GNRO-2004-00044

SUBJECT: Supplement to Relief Request
"Request for Relief GGNS-PRR-E21-02 for the Low Pressure Core
Spray Pump, 2nd IST Ten-Year Interval"
Grand Gulf Nuclear Station, Unit 1
Docket No. 50-416
License No. NPF-29

**Response to Request for Additional Information
Pertaining to Relief No. GGNS-PRR-E21-02**

LOCKING STEM NUT DEVICE
(CONCEPTUAL DESIGN)

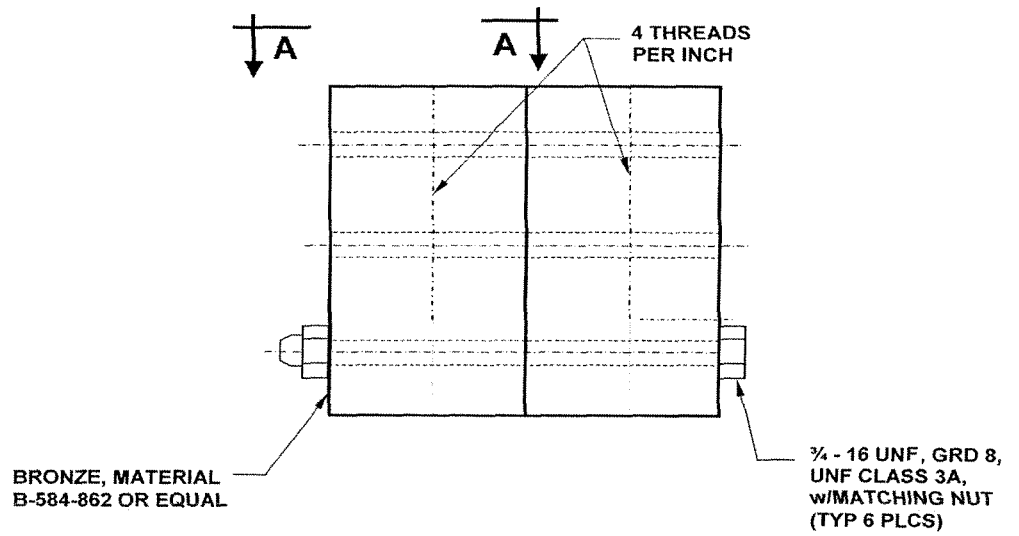
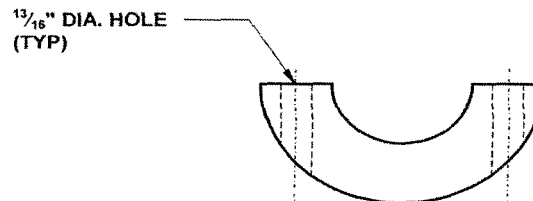
During a recent call to discuss the subject relief request, Entergy expressed their intent to install a mechanical restraint device for the duration of the proposed relief interval. Briefly describe the mechanical restraint device that GGNS intends to install on the LPCS valve during this period.

Entergy has performed detailed analysis to confirm that even in its current overthrust position the valve is considered structurally sound. However, in order to better assure industrial safety during this condition, Entergy intends a mechanical restraint device (i.e., locking stem nut) on the valve stem. This device will ensure that there is no inadvertent release of energy via the overthrust on the valve seat. The restraint will be designed and installed to add no additional stored energy to the valve actuator.

The locking stem nut will be comprised of two halves with each fitted to the exposed stem threads to ensure maximum engagement. Securing hardware used to join the two halves initially will be finger tight to allow the nut to be spun up hand tight against the underside of the yoke. Once the nut is in contact and snug with the underside of the yoke, the stem nut clamping fasteners will be tightened wrench tight.

This stem nut arrangement will maintain stem position without imparting any additional loads into the actuator assembly. The stem nut is designed and positioned to transfer the entire stem load to the underside of the valve yoke plate. Two simplified sketches of the restraint device are provided below.
